# Regional District of Comox-Strathcona

Please find attached the report that you loaned me last week.  
We were able to Xerox the plan adequately.

PRELIMINARY REPORT ON  
OYSTER RIVER FLOODING AND EROSION

DWG. No. 4918-73-31-16

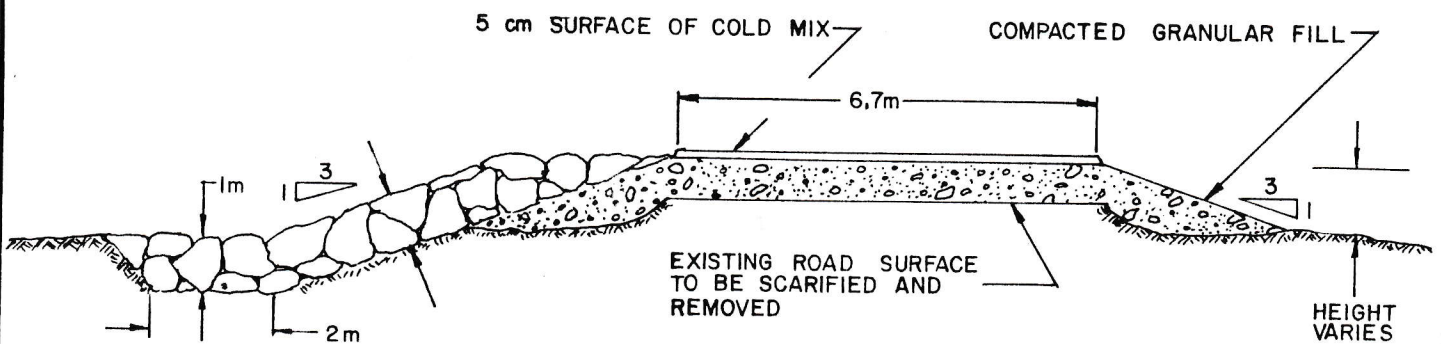
We have reviewed the report word for word and can find no absolute elevations. The references to dyke elevations are "elevations of the flood of record plus one meter". I am assuming the flood of record is the one in December 1980. More details will be required before construction.
